MEMORANDUM #2

SUBJECT: APPLICATION SUBMISSION – C VARIANCE
FOR BUILDING ADDITION
ZB-26-02
13 PORTER ROAD
BLOCK 175.24, LOT 3

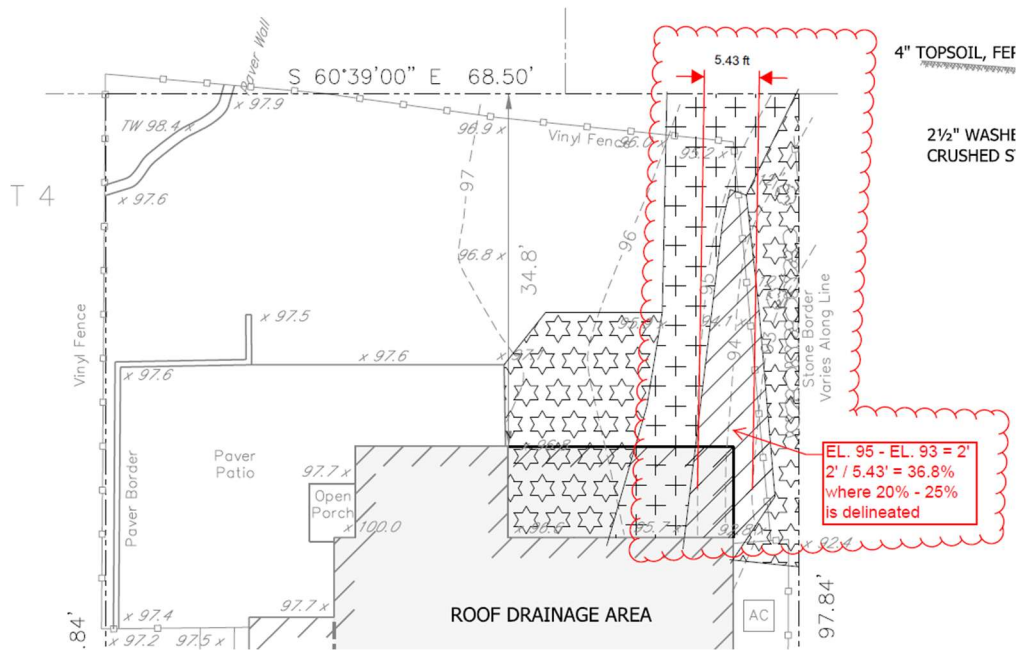
- 5.4 The plans shall be revised to include steep slope calculations in accordance with Chapter 25-28 of the Township Code;

➤ *Partially Addressed. The “Drainage & Grading Plan” provided includes a steep slope analysis table and associated plan. However, the provided plan does not appear to be correct. Based on the contour elevation provided, there are areas that are not properly delineated based on the slope in that area. Please see below for an example. The Applicant shall revise the plan and analysis table to eliminate these discrepancies.*
